Work Order ID 93725

Item Name: Replacement Window Assembly

DRAWING NO. D3290	TITLE REPLACEMENT WINDOW ASSEMBLY	REV. C	DART AEROSPACE LTD ENGINEERING ORDER		D.E.O. NO. D3290-C-1	SHEET NO. SHEET 1 OF 1	SCALE NTS
DRAWN 90	CHECKED b	MFG. APPR. E	APPROVED MP		DE APPR. H		
DATE 09.09.18	DATE 09.09.18	DATE 09.09.18	DATE 09/09/21		DATE 09/09/21

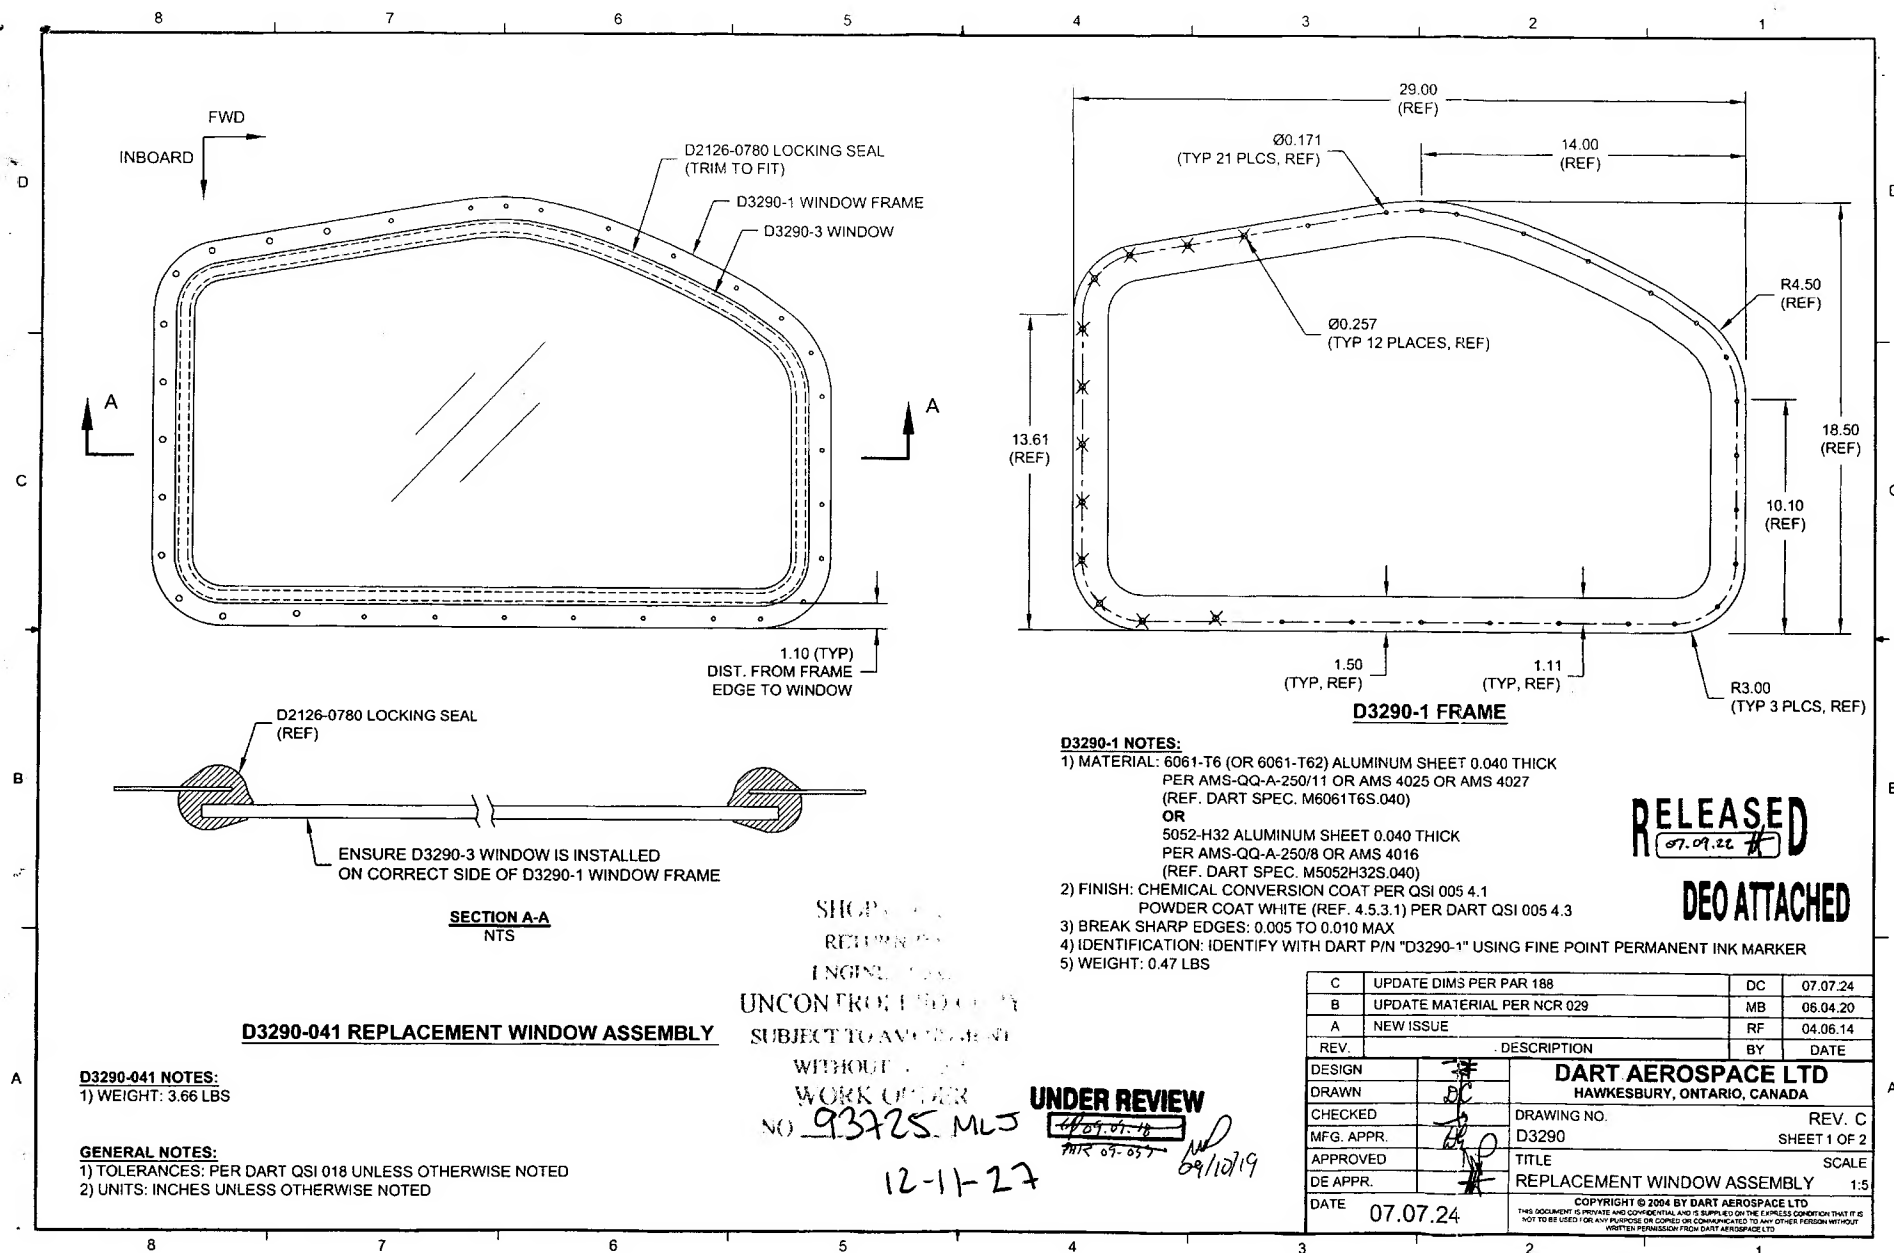
PURPOSE:

CHANGE MATERIAL THICKNESS OF D3290-1 FRAME TO 0.063 FROM 0.040. REF PAR 09-033.

MATERIAL CALL-OUT OF D3290-1 FRAME ON SHEET 1 IS AMENDED AS FOLLOWS:

- 1) MATERIAL: 6061-T6 (OR 6061-T62) ALUMINUM SHEET ~~0.040 THICK~~ 0.063 THICK (REPLACE)
PER AMS-QQ-A-250/11 OR AMS 4025 OR AMS 4027
(~~REF. DART SPEC. M6061T6S.040~~) REF. DART SPEC. M6061T6S.063 (REPLACE)
OR
5052-H32 ALUMINUM SHEET ~~0.040 THICK~~ 0.063 THICK (REPLACE)
PER AMS-QQ-A-250/8 OR AMS 4016
(~~REF. DART SPEC. M5052H32S.040~~) REF. DART SPEC. M5052H32S.063 (REPLACE)
